# Access Compliance Report Public Rights-of-Way (Curb Ramps)

Main Street: SIENNA\_PKWY Cross Street: MAIN\_ST Location: SE

ADA ID: RPRK211022123034 Ramp Type: Type 4 - Parallel Initial Pass/Fail: Pass Overall Compliance: No Severity Score: 26

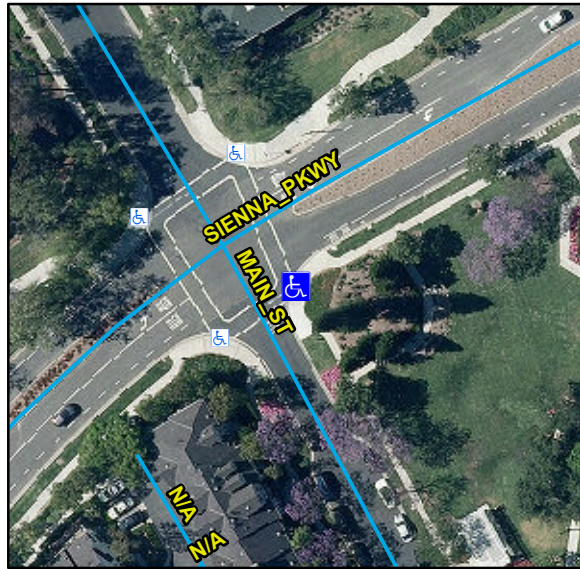
R204.3, R304.2.1, R304.2.2-Perp, R304.3.2-Para, R304.5.3, R305, R304.5.4, STD 1115

| Compliance | Description                   | Data       | Compliance | Description                   | Data |
|------------|-------------------------------|------------|------------|-------------------------------|------|
| N/A        | Landing Present               | No         | No         | DWS Provided                  | No   |
| No         | Landing Width (in)            | N/A        | N/A        | DWS Length (in)               | N/A  |
| No         | Landing Run Slope (%)         | N/A        | N/A        | DWS Full Width                | N/A  |
| No         | Landing Cross Slope (%)       | N/A        |            | DWS Offset Type               | N/A  |
| No         | Gutter Run Slope (%)          | 9.6        |            | Road Cross Slope (%)          | 1.5  |
| No         | Gutter Cross Slope (%)        | 4.4        | No         | Perpendicular Joint Present   | No   |

Remove & Replace Curb Ramp With Two New Directional Ramps or Equivalent. Remove & Replace Gutter.
